**AGENDA**  
**CITY OF STURGEON BAY**  
**AESTHETIC DESIGN & SITE PLAN REVIEW BOARD**

Monday, October 12, 2020

To: Aesthetic Design and Site Plan Review Board  
From: Christopher Sullivan-Robinson  
Date: October 8, 2020  
Subject: Roof Pitch Request by Sherrelle Schmidt

To: Aesthetic Design and Site Plan Review Board  
From: Christopher Sullivan-Robinson  
Date: October 8, 2020  
Subject: Bay Electronics Garage Replacement

1 Building Plan  
3/16" = 1'-0"

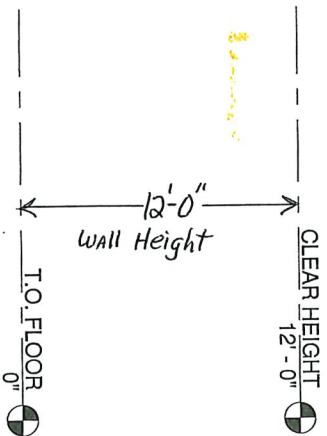
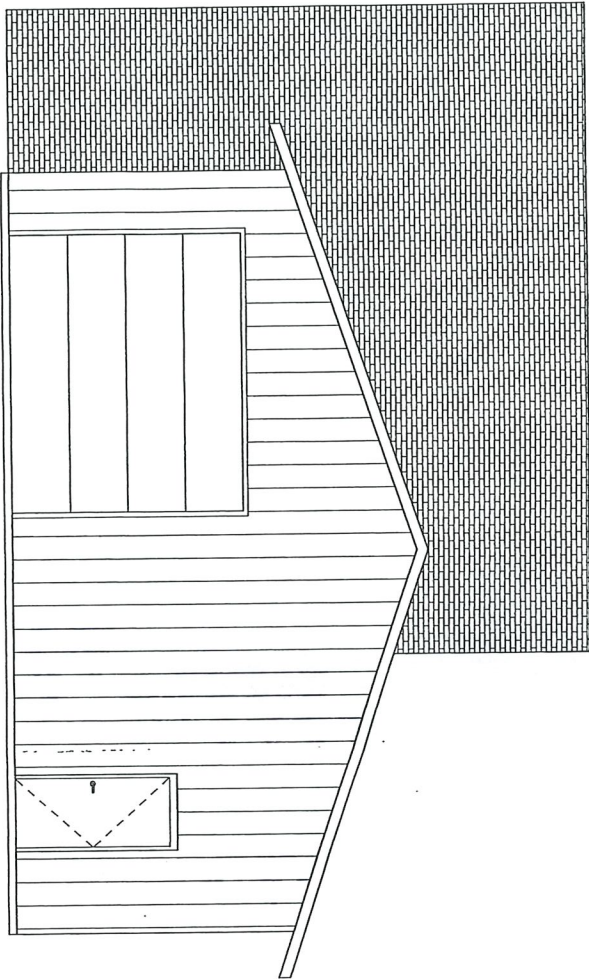
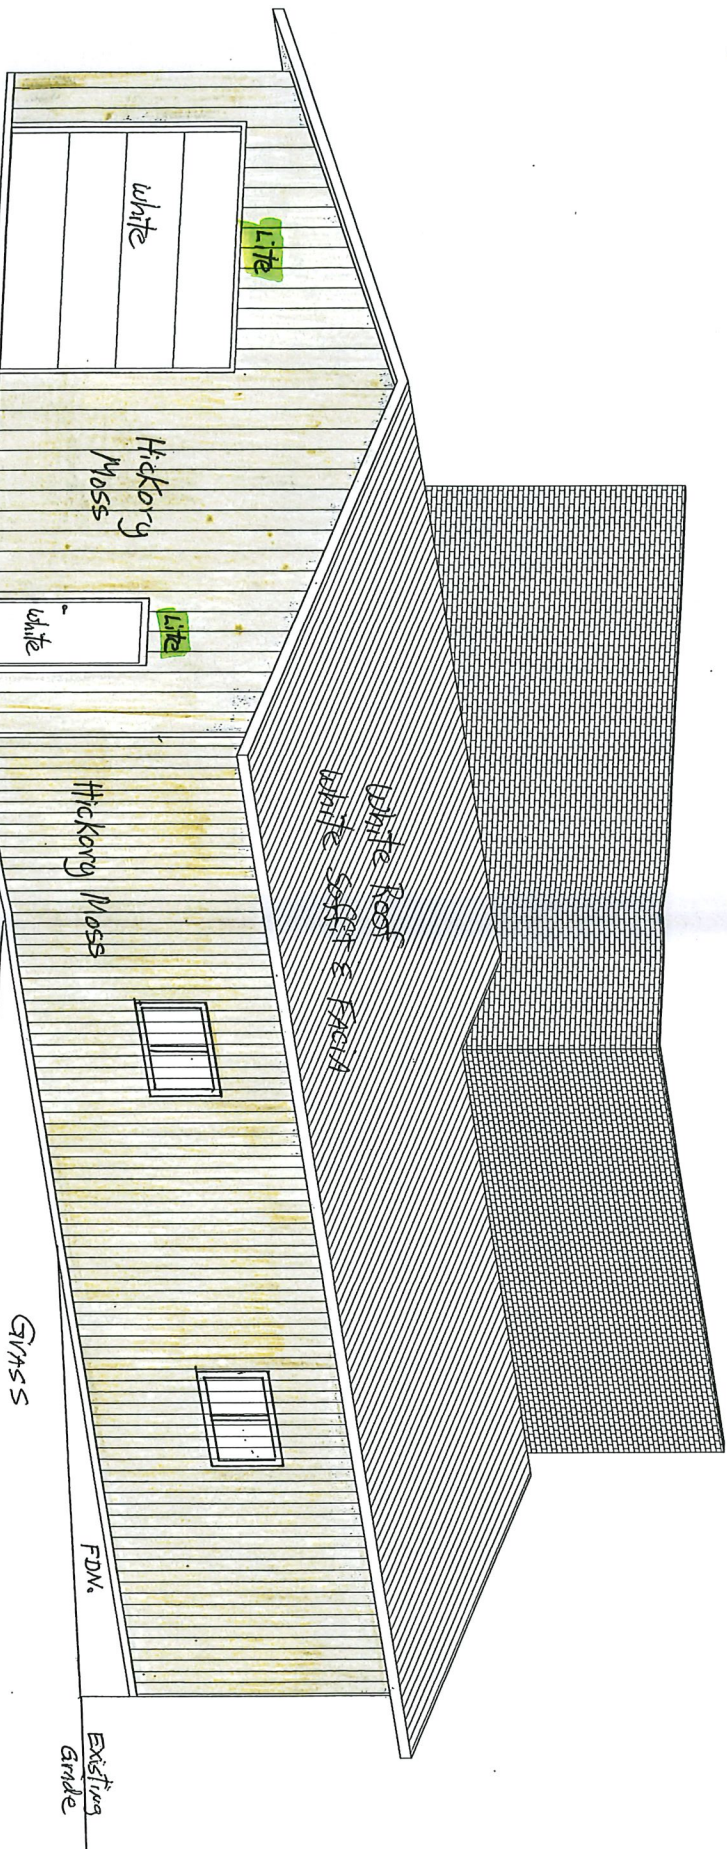
*The east and north walls will be visible from the street right-of-way. The length of the east wall is 86 feet, which is fairly long. There are two windows proposed on this side; however, the committee could require additional plants or structural alterations to break up this long wall.*

*The east wall should be reviewed by committee.*

*These light fixtures are not shielded, so there is the potential for lighting to be casted onto adjoining property that abut the alley.*

*These light fixtures produce 2600 lumens. The average high beam on a vehicle is 1200.*
